ADDENDUM NO. 3

**CITICO PUMP RELIABILITY IMPROVEMENTS
City of Chattanooga Project W-16-013-201
Burns & McDonnell Project 95307**

CITY OF CHATTANOOGA, TENNESSEE

Figure 1 - 72-inch RCP Construction Photograph

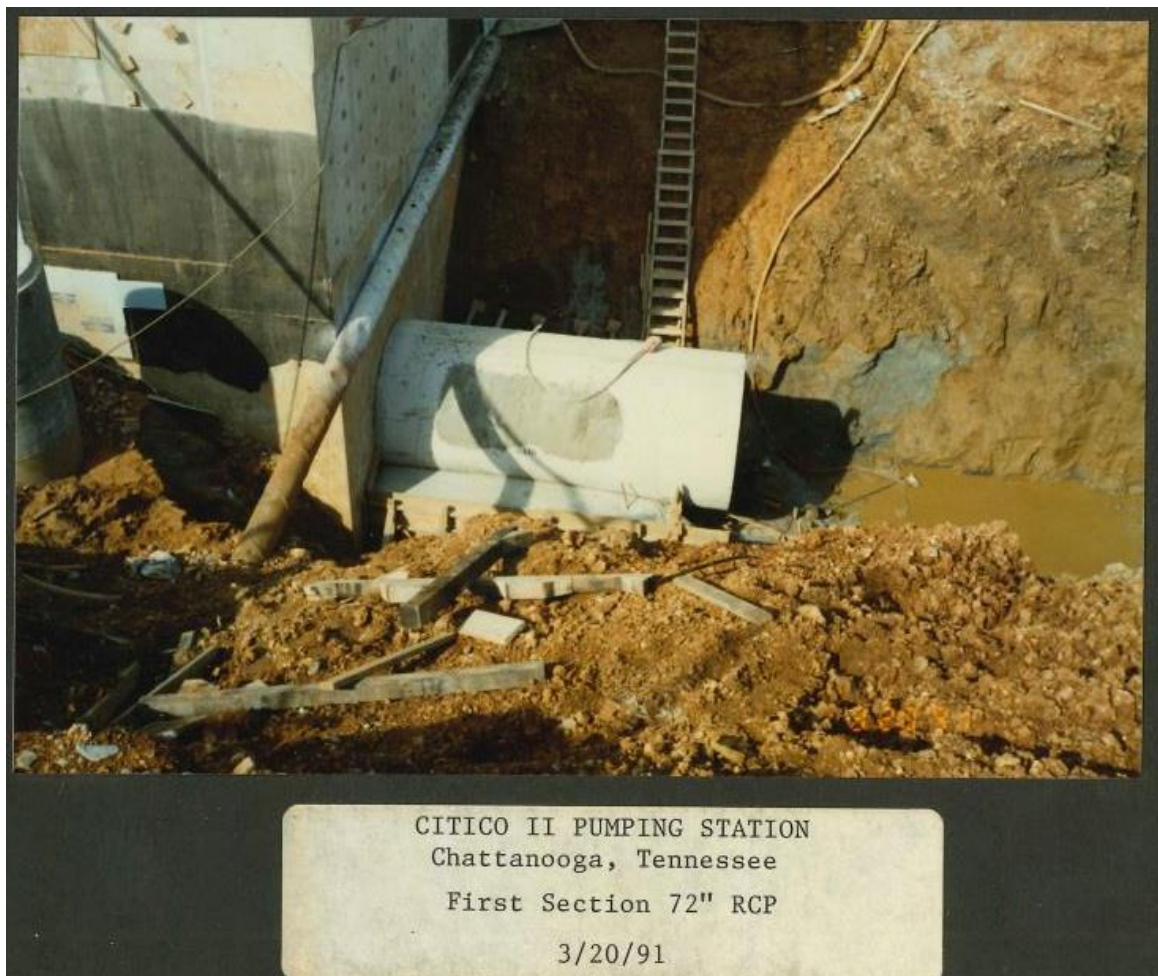
Question: Can the City of Chattanooga or the Engineer provide the class of pipe and pipe lengths (between joints) for the existing 72” RCP line between the existing junction box and existing Citico Pump Station?

Response: Record Drawings and construction photos indicate the gravity interceptor entering Citico Pump Station from the north is tongue-and-groove 72-inch RCP. Specifications of this pipe are not known. Construction photos indicate first length of pipe north of the pump station may be approximately 20-feet long. Lay-lengths between joints north of this first segment are unknown. Refer to Figure 1 below.
